Subject: Class 1 Permit Modification Notifications, Waste Isolation Pilot Plant Hazardous Waste Facility Permit Number: NM4890139088-TSDF

Class 1 Permit Modification Notifications

Revise Text in Permit Part 1, Sections 1.15.1 through 1.15.5, Regarding Tribal Community Notice and Involvement
 Revise Text in Permit Attachment A1 Concerning the Flood Zone Designation for the WIPP Facility

WIPP Permit Number - NM4890139088-TSDF

FIGURE 1 - FLOOD ZONE DESIGNATION FOR WIPP FACILITY

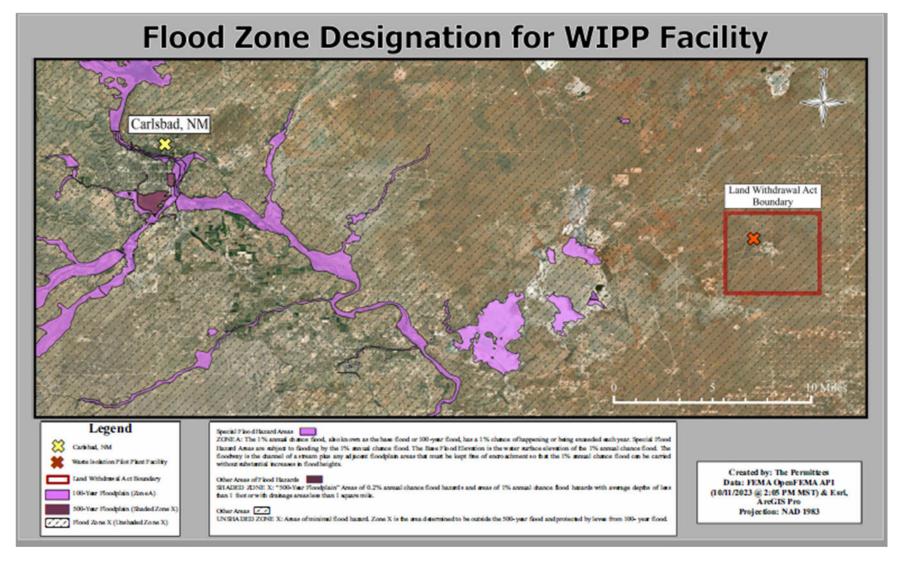
Text addressing 20.4.1.500 NMAC (incorporating 40 CFR §270.14(b)(11)(iii) and (iv)) regarding the 100-year flood plain evaluation was added to clearly explain that the WIPP facility does not lie within a 100-year floodplain, therefore the requirement pertaining to floodplains therein do not apply to the WIPP facility. Additionally, to address the language in the Agreement, the Permittees have evaluated the location of the WIPP facility in relation to the designated 500-year floodplain. As a result of that evaluation, text was added to show that Permittees have confirmed the WIPP facility is situated outside of the 500-year floodplain.

Flood hazard areas are categorized by the Federal Emergency Management Agency (FEMA) into three main groups: Special Flood Hazard Areas (SFHA), moderate flood hazard areas, and areas of minimal flood hazard. The areas classified as SFHA are defined as that which will be inundated by a flood event having a 1% annual chance of being equaled or exceeded in any given year. The 1% annual chance flood is also referred to as a 100-year flood zone. Moderate flood hazard areas represent the areas between the limits of the base flood and the 0.2% annual-chance (or 500-year) flood. The areas outside of the SFHA and in a location that maintains a higher elevation of the 500-year flood are considered to be areas of minimal flood hazard. The Land Withdrawal Act boundary is located within the areas of minimal flood hazard, maintaining the requirements for elevation and proximity to the SFHA as depicted in Figure 1. Figure 1 in Attachment B was developed by the Permittees using the FEMA Flood Insurance Rate Layer to demonstrate the proximity of the entire facility to the nearest flood zone. Figure 2 depicts the northern portion of the WIPP facility located on the FEMA Flood Insurance Rate Map. Figure 3 depicts the southern portion of the WIPP facility located on the FEMA Flood Insurance Rate Map. As shown in Figure 1, the WIPP facility lies within Unshaded Zone X. outside of both the 100-year floodplain and the 500-year floodplain. The FEMA identifies No Screen Zone X as an Area of Minimal Flood Hazard in Figure 2 and Figure 3.

- The following text was added to the new paragraph beginning with "A design-basis flood report is not available because ...": "The regulations in 20.4.1.500 NMAC (incorporating 40 CFR §270.14(b)(11)(iii)) require facilities to provide an identification of whether the facility is located within a 100-year floodplain. The WIPP facility does not lie within a 100-year floodplain, therefore the requirement pertaining to floodplain in 20.4.1.500 NMAC (incorporating 40 CFR §270.14(b)(11)(iii) and (iv)) does not apply to the WIPP facility. Although, the Settlement Agreement and Draft Permit dated June 23, 2023, (Item 7e) stated a Class 1 modification would be submitted to change the 100-year floodplain designation to the 500-yr floodplain designation, the Permittees evaluated whether the WIPP facility lies within the Federal Emergency Management Agency (FEMA) designated 500-year floodplain and determined that the WIPP facility does not lie within a 500-year floodplain."
